Name Of Dam: KINLOCH FARM DAM
Location: FAUQUIER COUNTY
Inventory Number: VA. 06109

Kinloch Farm Dam. Inventory Number:
VA-06109. Fauquier County, Virginia.
Phase I Inspection Report.

11 FEB 1979

PHOTOGRAPH NO. 6
Downstream Channel of Secondary Spillway

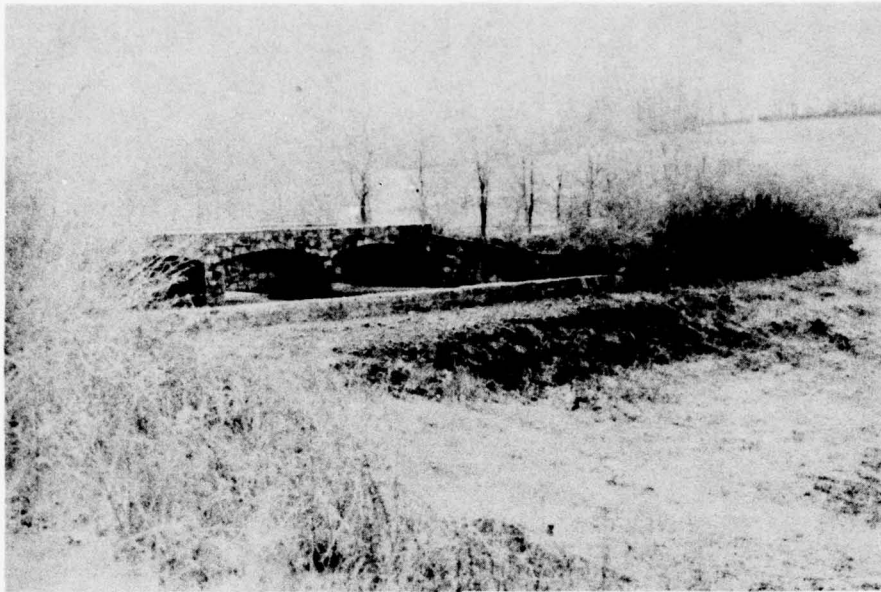
There were two massive olivine basalt outcrops along either side of the secondary spillway. There was a small seepage area observed in the secondary spillway between the two rock outcrops. According to Mr. Harmon Stevenson, the General Superintendent of Kinloch Farm, the seepage area existed prior to construction of the dam.

3.2 Evaluation: The visual inspection revealed no apparent problems requiring immediate attention other than the wet area of the downstream reaches of the secondary spillway channel. Since the pool was drained during the site inspection and since the seepage area reportedly existed prior to construction of the dam, it is believed that the seepage water is supplied from the hillside to the left of the dam. The two rock outcrops along either side of the spillway suggest that the basalt may form a cradle along which water from the adjacent hillside is routed. It is not felt that this seepage will adversely affect the dam, although the source of the seepage should be checked.

7.2 Remedial Measures/Recommendations: It is recommended that geotechnical exploration and evaluation of the dam be conducted, at the owner's expense, as outlined in Section 6.3. In addition, the source of the seepage in the secondary spillway shall be determined. The combined capacity of the spillways must be increased to pass the $\frac{1}{2}$ PMF without overtopping the embankment. A warning system procedure should be established to alert residents in case of an emergency.
